**1411 South Potomac**  
1411 South Potomac  
Aurora, CO 80012  
**Suite 420**

**Lynn Institute**

City of Aurora Building Division  
Reviewed for Code Compliance  
Approved as Noted: **W. Griffin**  
Date: **Feb 21, 2018**  
2015 INTERNATIONAL CODES & 2017 NEC

**A2.0**

**1 MECHANICAL PLAN**  
M1.0 SCALE: 1/4" = 1'-0"

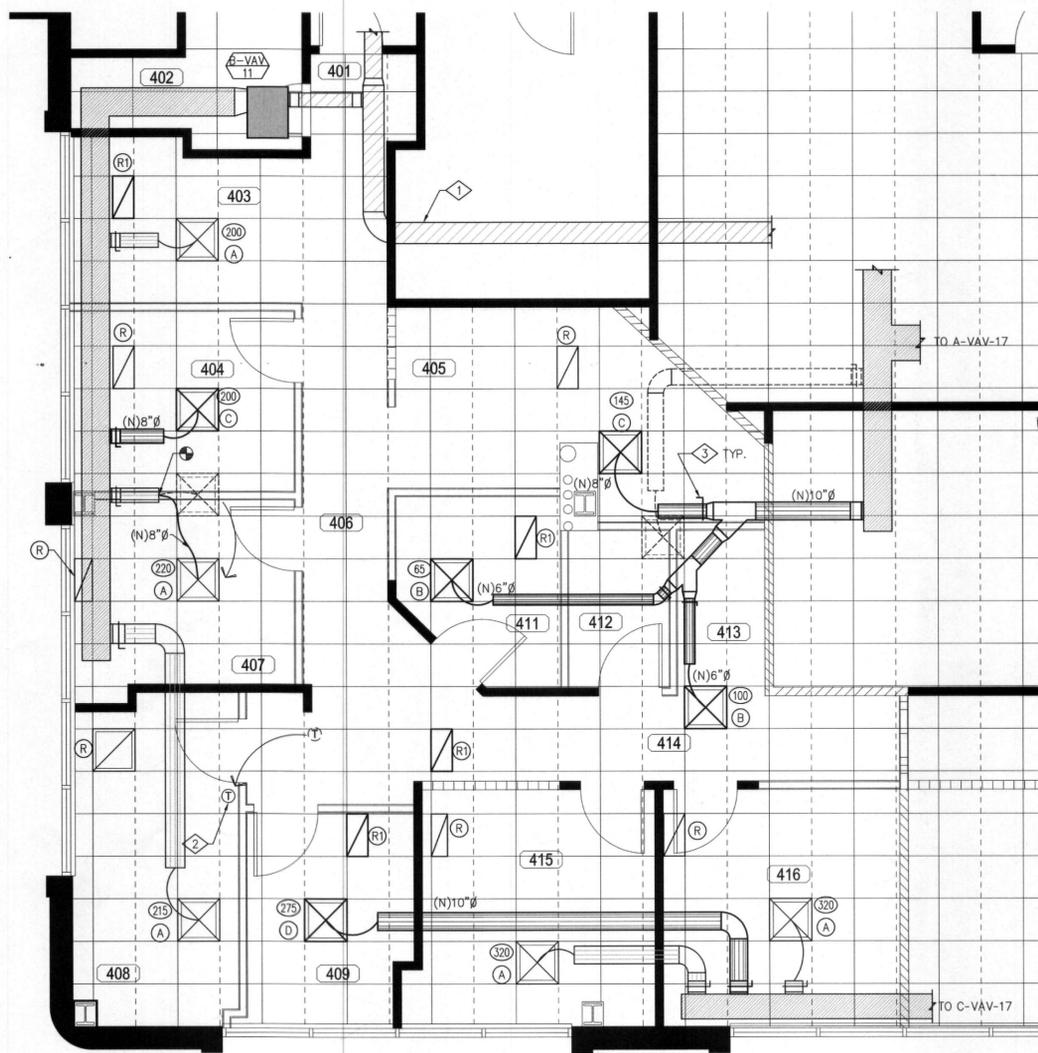
Heating system shall be capable of maintaining 68 degrees F a 3'0" above the floor.  
2015 IMC 309, IRC 303.9 and IBC 1204.1

Provide proof of a flame spread less than 26 and a smoke development less than 50 for any material used in a plenum.  
2015 IMC 602.2.1

**POWER PLAN**

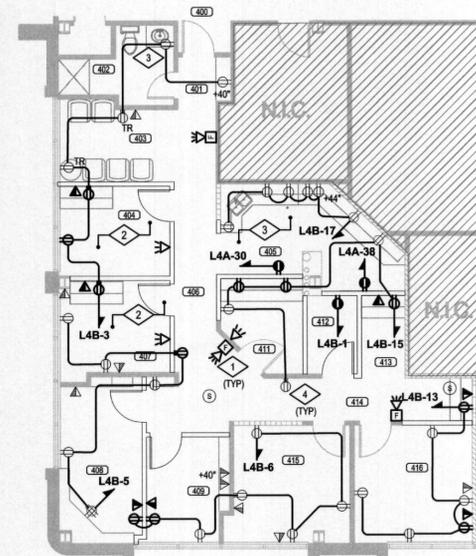
Install electrical connections per 2017 NEC 110.14, identify disconnects per 2017 NEC 110.22 and provide working space around electrical equipment per 2017 NEC 110.26.

Wiring in air handling spaces must comply with 2017 NEC 300.22. Firestop penetrations per 2017 NEC 300.21. Secure and support equipment per 2017 NEC 300.11.

Legibly identify each breaker or switch for it's use or purpose on the circuit directory in the panel/switchboard per 2017 NEC 408.4.

**LIGHTING PLAN**

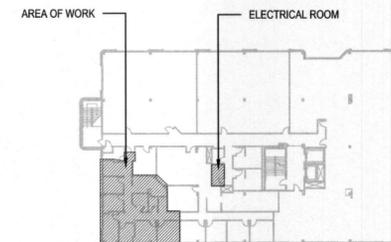
Provide emergency illumination equipment that complies with 2017 NEC 700.12 (F) or 2017 NEC 700.

Suspended ceiling systems and the luminaires they support shall meet the requirements of 2017 NEC 410.36(B).

After hours inspection to verify required egress illumination may be required during field inspection. 2015 IBC 1006.
